Economic Commission for Europe**Inland Transport Committee****World Forum for Harmonization of Vehicle Regulations****Working Party on Noise and Tyres****Seventy-ninth session**

UN Regulation No. 138 (Quiet road transport vehicles)**Proposal for a new series of amendments to UN Regulation
No. 138****Submitted by the experts from the Task Force on Quiet Road
Transport Vehicles***

UN Regulation No. 138

Uniform provisions concerning the approval of Quiet Road Transport Vehicles with regard to their reduced audibility (QRTV)

Figure 5
~~Vehicle A-Weighted sound pressure level measurement correction criteria~~
Background noise requirements

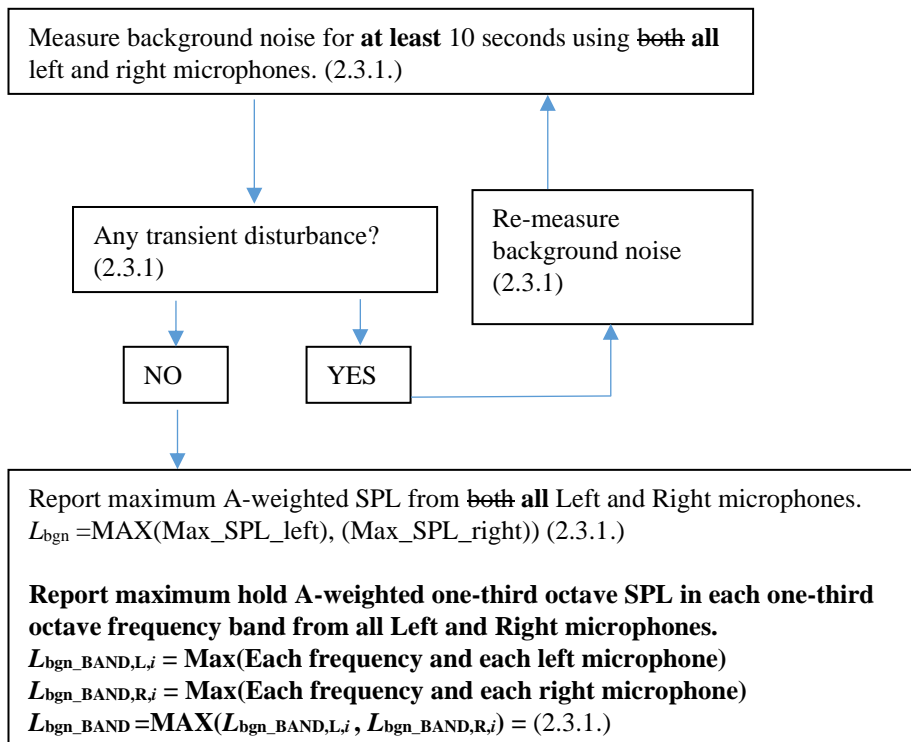
As an aid for measurement correction criteria see flowchart in Figure 5 of the appendix to this annex.

Test procedures for measurement of frequency shift (~~method E deleted; method A ?~~)

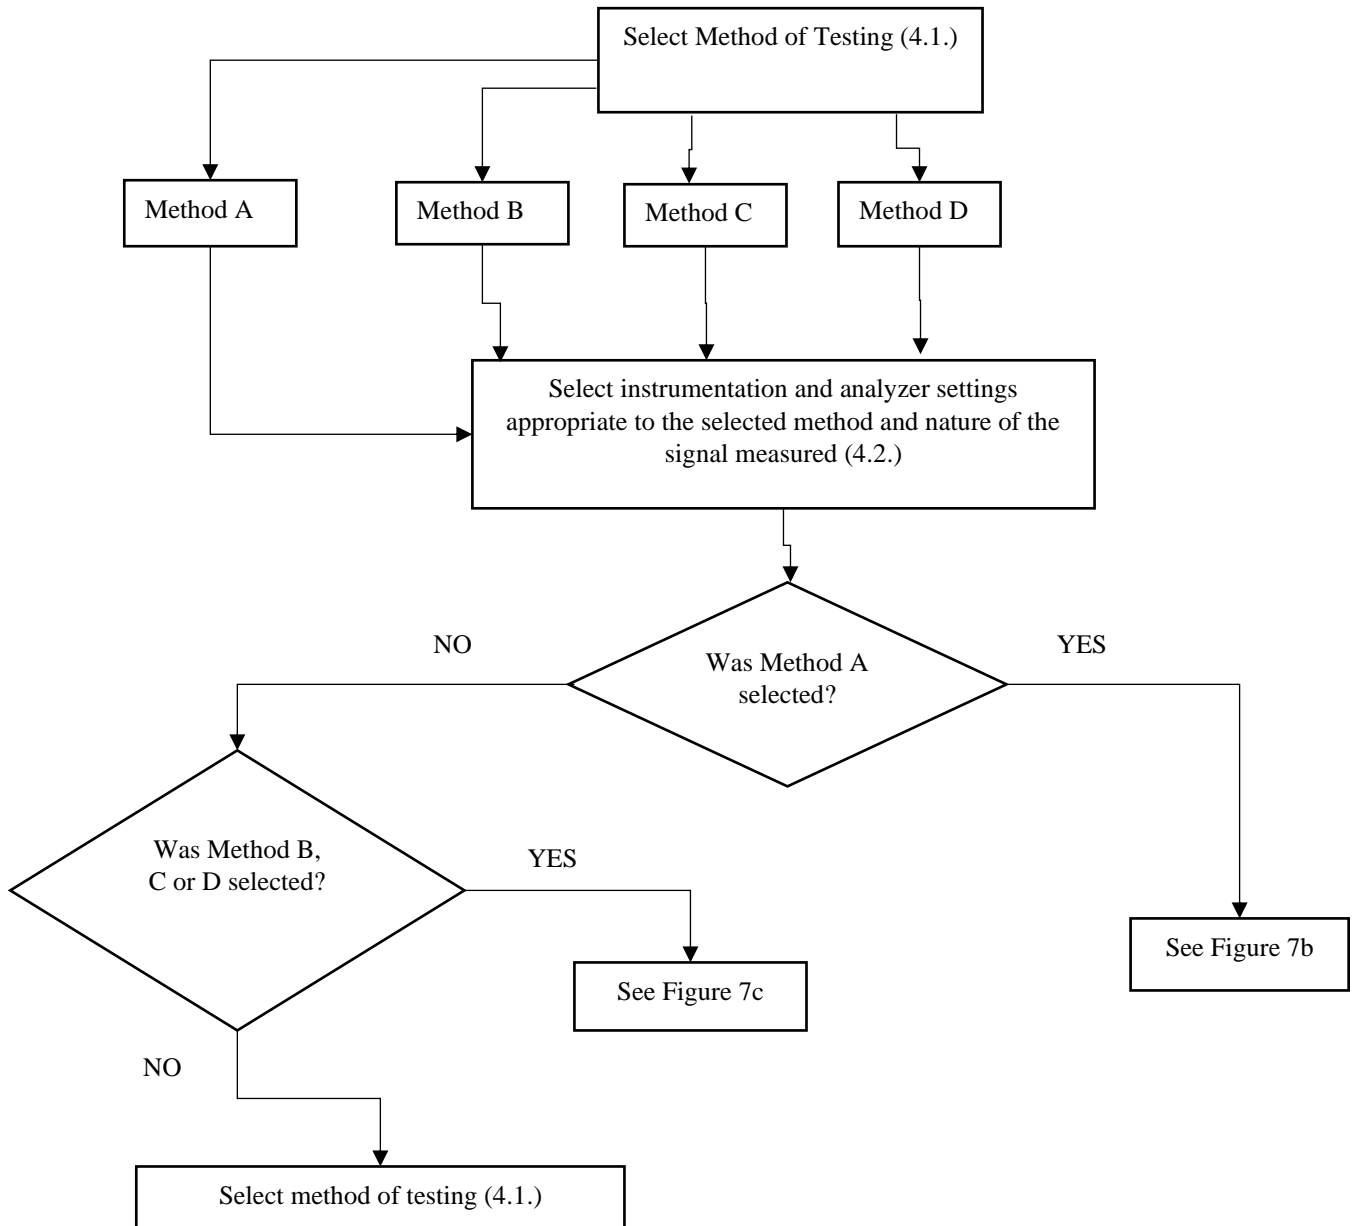
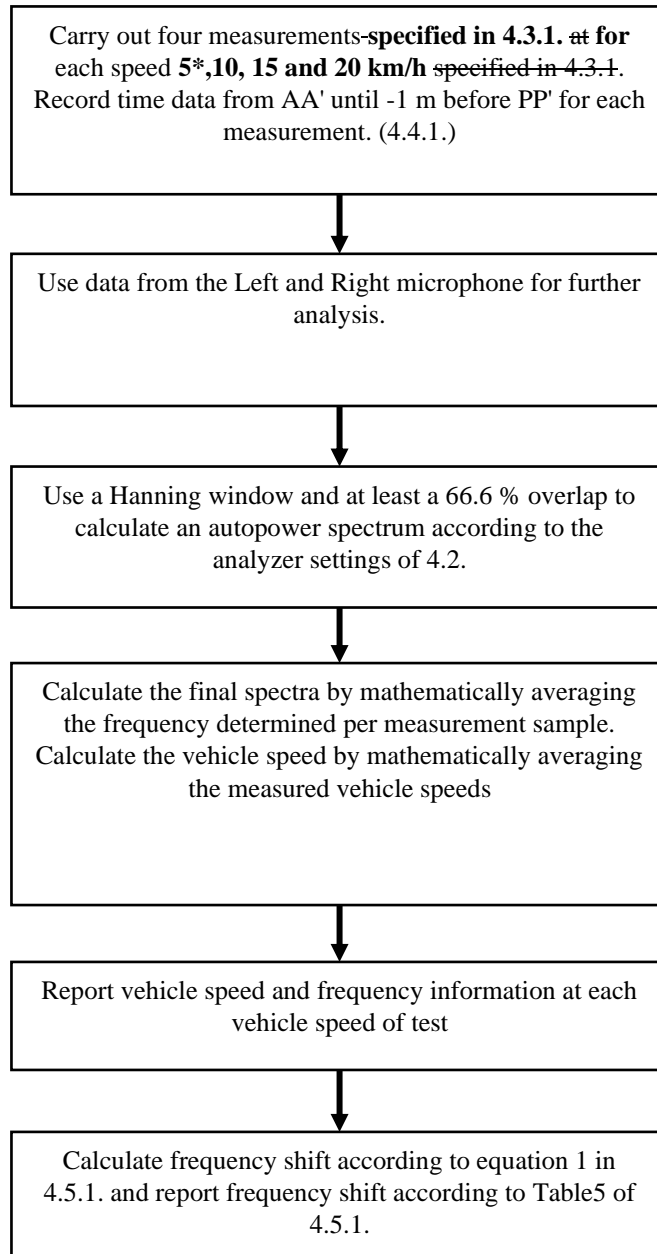
* Note by the secretariat: as an aid for measurement of frequency shift see flowchart in Figure ~~67a, 67b~~ or ~~67c~~ of the Appendix to this annex.
